CLIENT Seamus and Deirdre O'Dwyer
PROJECT Proposed Extension & Alteration To Existing Dwelling, Attic Conversion
ADDRESS 43 Pineview Rise, Aylesbury, Tallaght, Dublin 24 D24 PK2K
PROJECT NO. 22314

DRAWING TITLE Extension & Attic Conversion
ISSUED Planning Permission

22314-PP- 2b

Section View

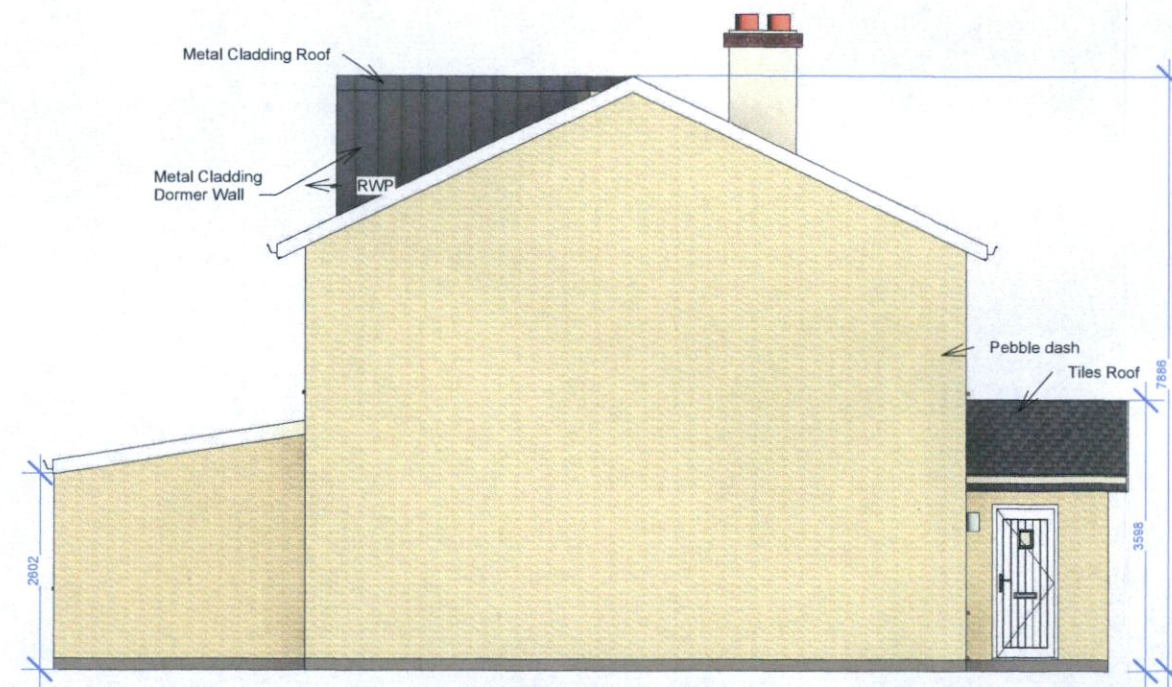
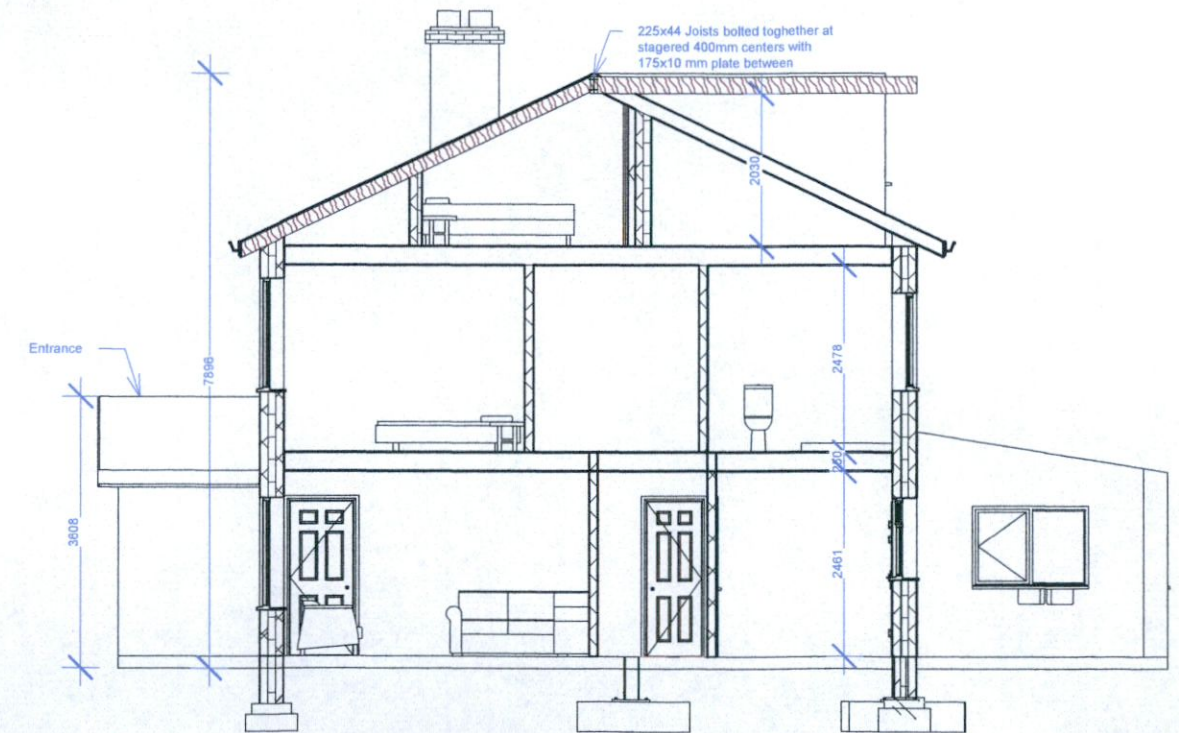
Internal Finish Floor level, Eternal Ground Level & the threshold of the sliding door should also be at the same level. A Acro Drain needs to be fitted outside the sliding doors to maintain internal & external level. This prevents moisture entering the property.
